PUBLIC INTEREST REVIEW FOR GROUNDWATER APPLICATIONS

SUBJECT: Application G- 17979 Supersedes review of 3/17/2015
Date of Review(s)

A. GENERAL INFORMATION: Applicant's Name: Phillip Ross Defenbaugh County: Harney

A1. Applicant(s) seek(s) 2.31 cfs from 2 well(s) in the Malheur Lake Basin,
Willow Creek subbasin Quad Map: Pole Canyon

Theis Time-Drawdown – To Warm Spring

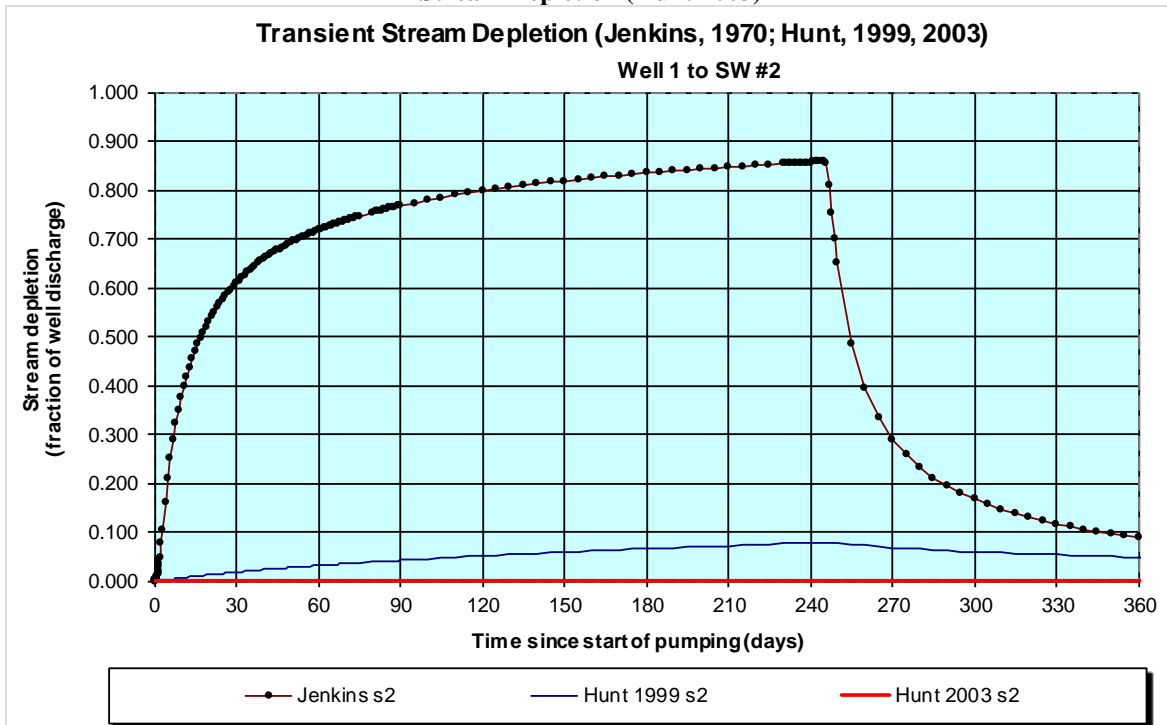
C4a. The potential drawdown at Warm Spring was calculated using the Theis equation with a range of values for transmissivity (see attachment). The values used in the calculation are conservative and appropriate until better values become available. At the pro-rated rate of the full duty over the full irrigation season (1.1 cfs), the results show a drawdown of 0.2-4.9 feet.

Stream Depletion (Hunt 2003)

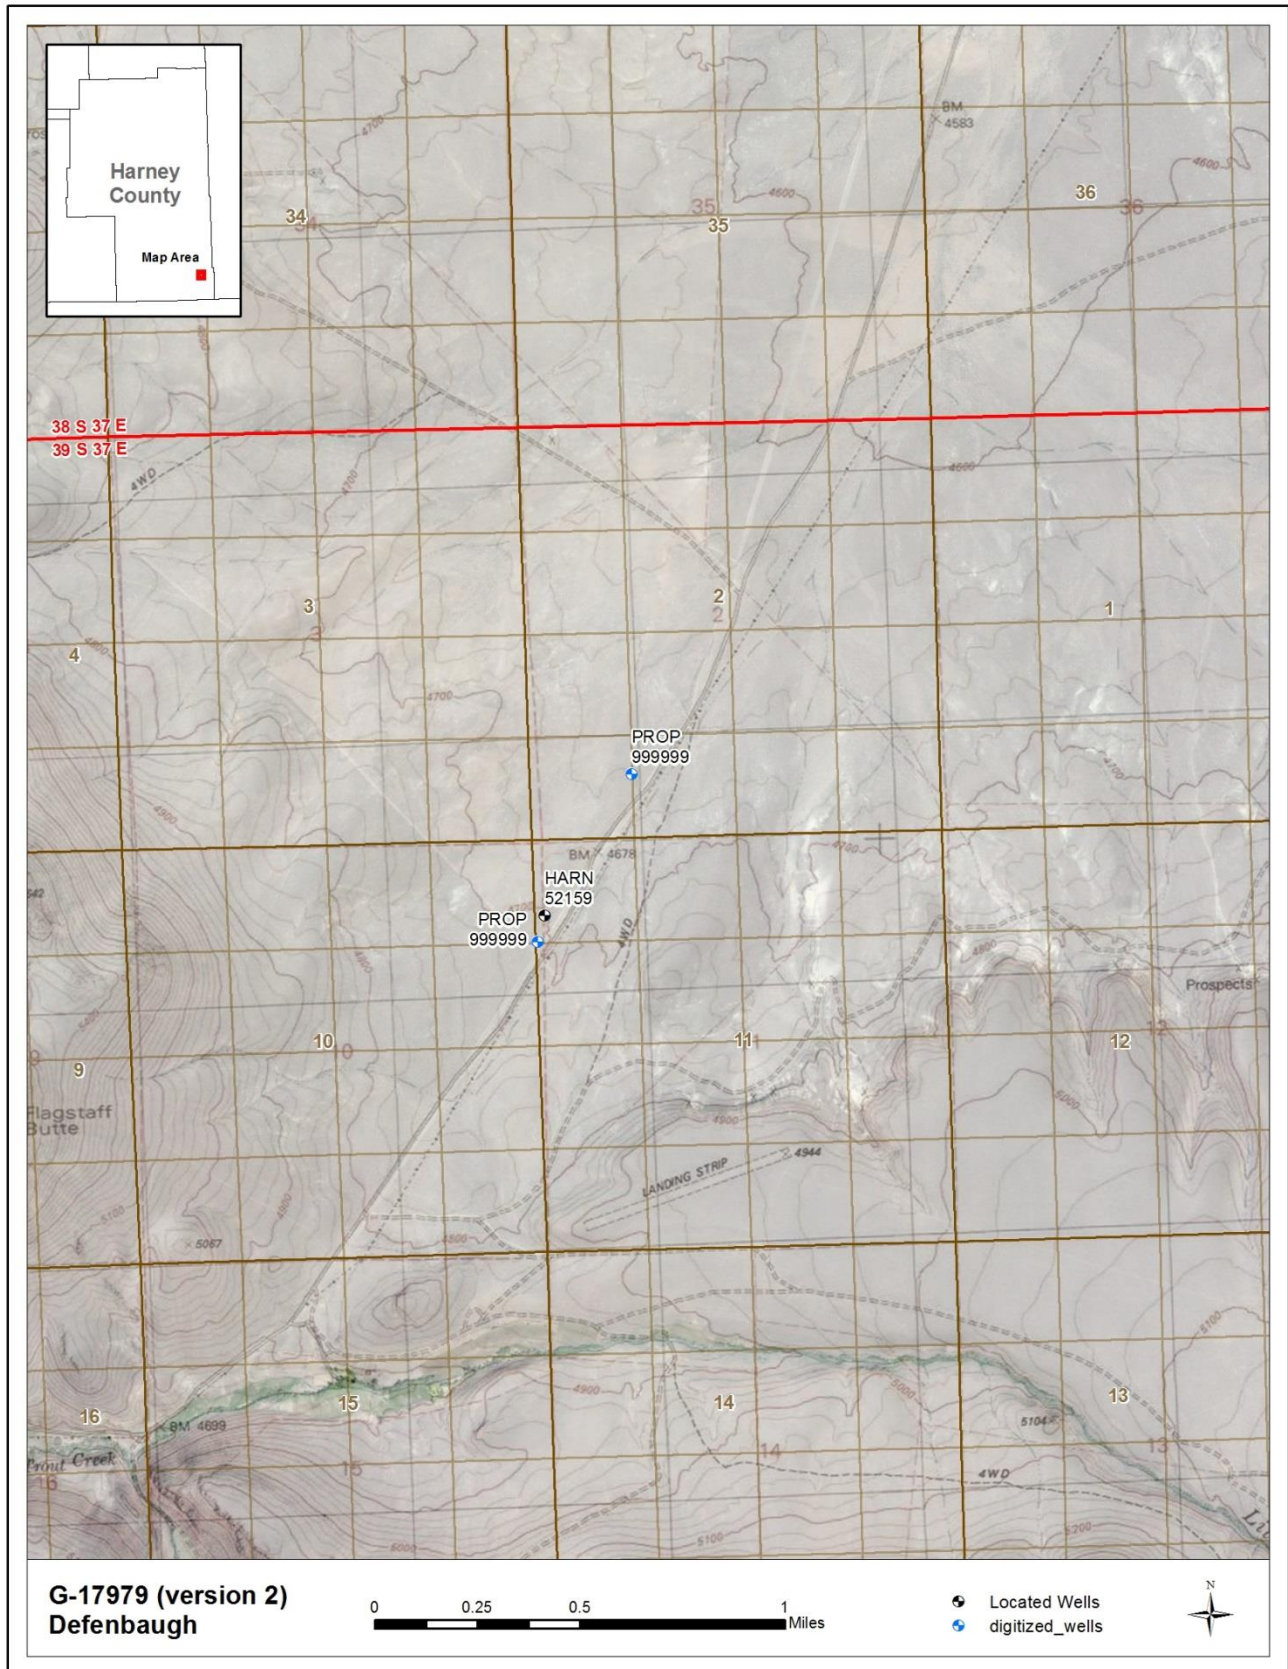
C4a. Hunt (2003) was used to calculate the interference between Well 1 and SW #2 with a range of values for transmissivity. The values used in the calculation are conservative and appropriate until better values become available. The calculation considered a range of transmissivity from 100-10,000 ft²/day. The pumping rate used represents the maximum allowable duty prorated over the irrigation season (1.1 cfs). See report attached.

Interference is determined to be much less than 1% of the 80% flow in all months evaluated.
